# MIDLAND - UNDERGROUND PIPING

MIDLAND PROJECT  
MIDLAND DOCKET NOS 50-329, 50-330  
UNDERGROUND PIPING CONCERNS  
FILE 0485.16 SERIAL 15093  
ENCLOSURE: ANALYSIS OF BURIED PIPING FOR MIDLAND PLANT  
UNITS 1 AND 2

ANALYSIS OF BURIED SAFETY-GRADE PIPING  
FOR  
MIDLAND PLANT UNITS 1 AND 2

Previous questions on underground piping were Q.17 & Q.45

FIGURE II-1

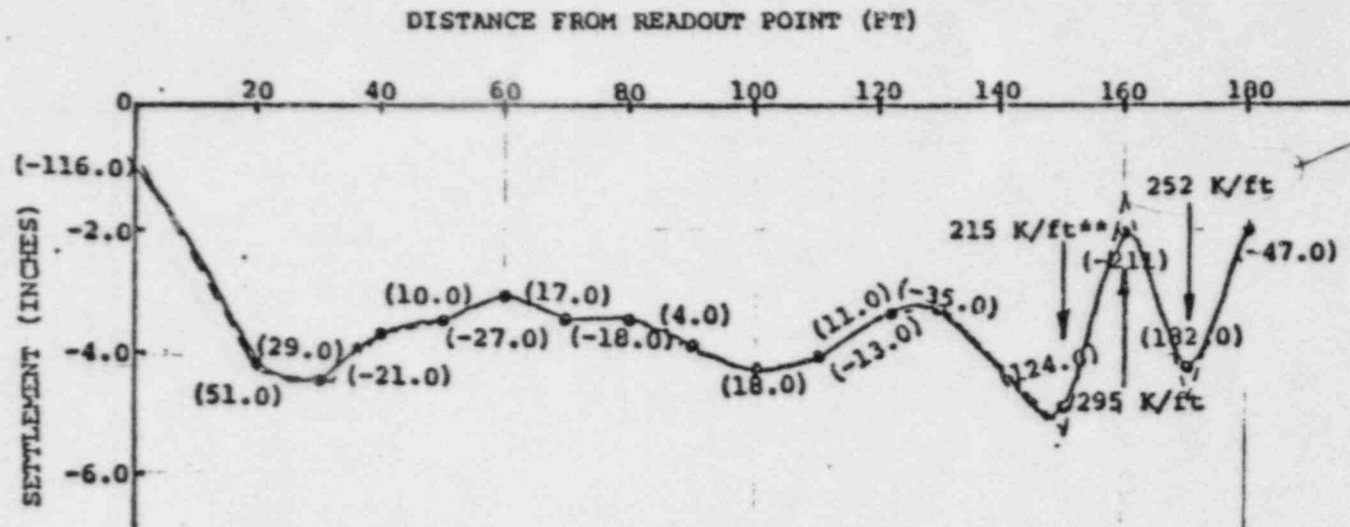
Not clear how calculated  
 $w = ?$   
 26"  $\phi$  Pipe  
 $L = 20$   
 $\Delta_{max} = \text{deflection @ center} = \frac{5WL^4}{384EI}$  Pg. 6-25 C.E. Handbook  
 $\Delta_{scaled} = 2.1"$   
 $\therefore 2.1" = \frac{5 \cdot w \cdot (20 \times 12 \frac{in}{ft})^4}{384 \times 30,000 \frac{K}{in^2} \times \frac{(26^4 - 25^4) in^4}{64}}$

FIGURE III-4

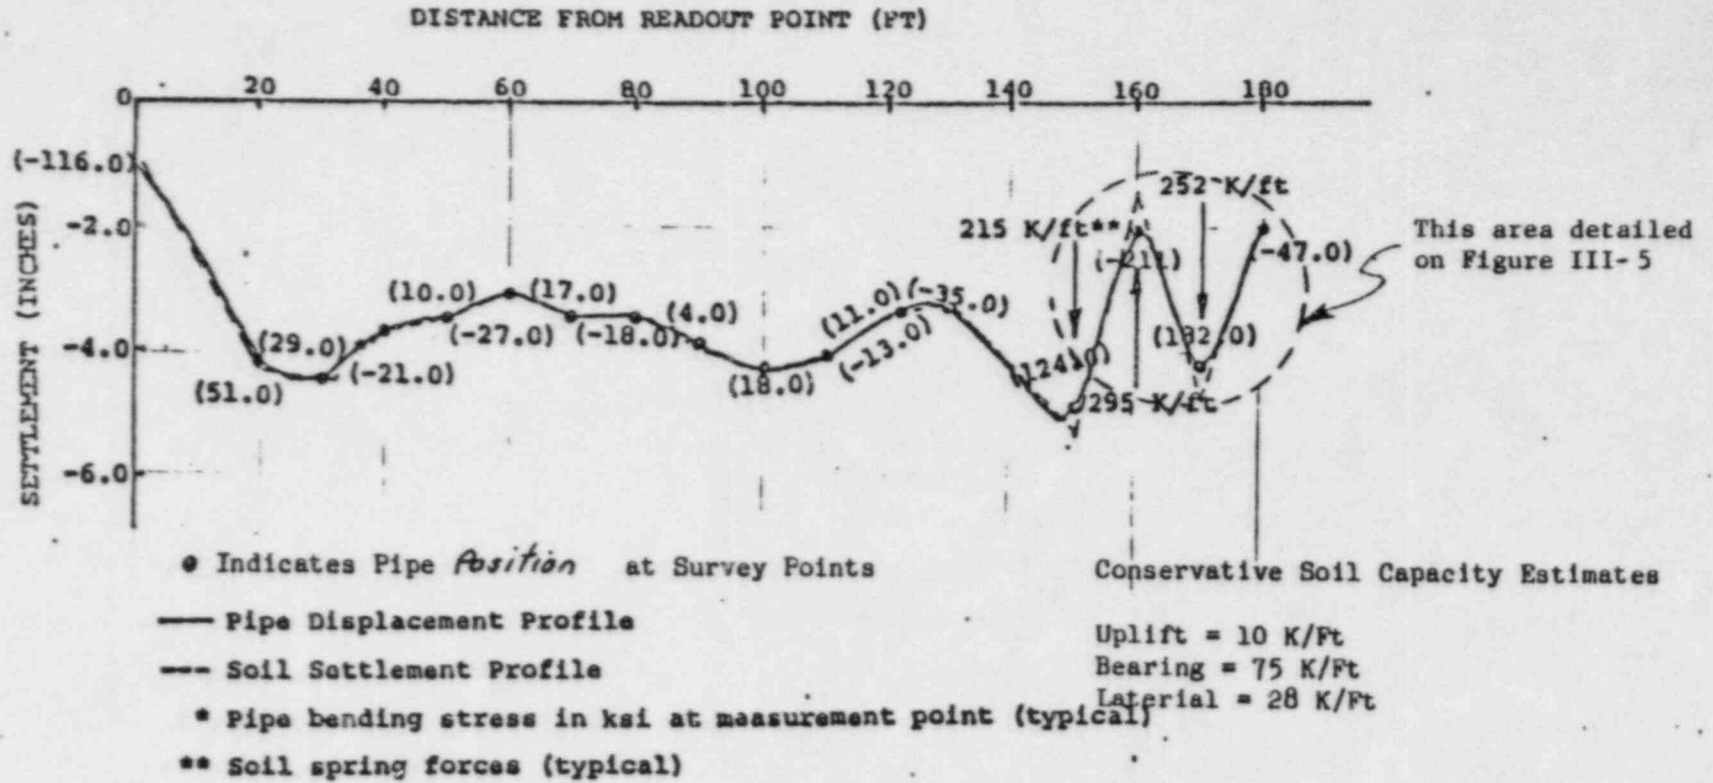
To understand this calculation & comparison it would be helpful to know the actual pipeline involved, where the distances are measured along that pipeline (is it in the surcharged area?), elevation of C datum for settlement, properties (i.e. moment of inertia) of the pipe. It is also unclear how the "conservative soil capacity estimates" shown on Fig. II-2 were determined and if they should properly be compared to the soil loading calculated by modeling the pipe as a beam on an elastic foundation.
